# Access Compliance Report

## Public Rights-of-Way

Intersection ID: 29416	Main Street: PADDORBORN_CT	Cross Street: SALINGER_WY	Location: E
ADA ID: 9000947596B6	Ramp Type: Perp	Initial Pass/Fail: Fail	Overall Compliance: No
Codes/Mitigation Info/Possible Solution		Field Measurements/Component Compliance	
Severity Score: 33.75

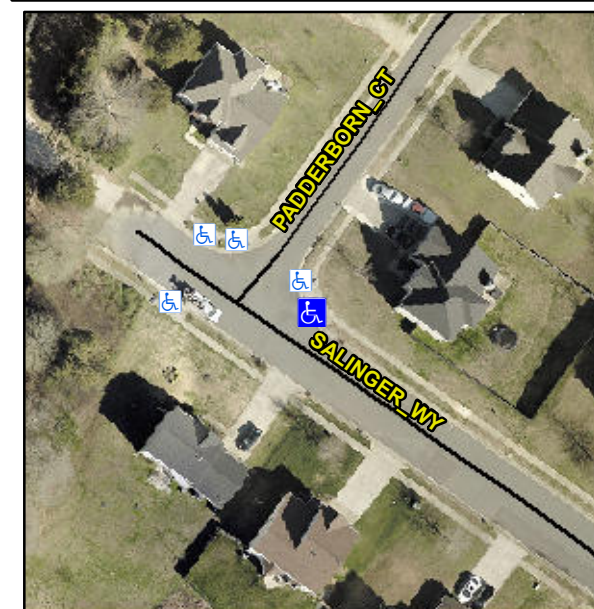
**Not Found, R304.5.1, R304.2.2**

Compliance	Description	Data	Compliance	Description	Data
N/A	Ramp Length (in)	62.5	No	Ramp Slope (%)	13.8
No	Ramp Width (in)	45.5	Yes	Ramp XSlope (%)	1.4
N/A	Flare Type LT	N/A	N/A	Flare Type RT	N/A
N/A	Flare Slope LT (%)	N/A	N/A	Flare Slope RT (%)	N/A
N/A	Flare Traversable LT?	N/A	N/A	Flare Traversable RT?	N/A
N/A	Landing Length (in)	N/A	N/A	DWS Provided?	N/A
N/A	Landing Width (in)	N/A	N/A	DWS Contrast?	N/A
N/A	Landing Slope (%)	N/A	N/A	DWS Length (in)	N/A
N/A	Landing X Slope (%)	N/A	N/A	DWS Full Width?	N/A
N/A	Landing Curb? (Y/N)	N/A	N/A	DWS Offset (in)	N/A
N/A	Shared Landing?	N/A			
N/A	Gutter Ponding?	N/A	N/A	Gutter Slope (%)	N/A
N/A	Gutter Lip Ht (in)	N/A	N/A	Gutter X Slope (%)	N/A
N/A	Painted X Walk1?	No	N/A	Painted X Walk2?	N/A
	X Walk 1 Direction	To SW		X Walk 2 Direction	N/A
N/A	X Walk 1 Width (in)	N/A	N/A	X Walk 2 Width (in)	N/A
	X Walk 1 Slope (%)	4.1		X Walk 2 Slope (%)	N/A
	X Walk 1 X Slope (%)	3.4		X Walk 2 X Slope (%)	N/A

**Remove & Replace Entire Ramp.**
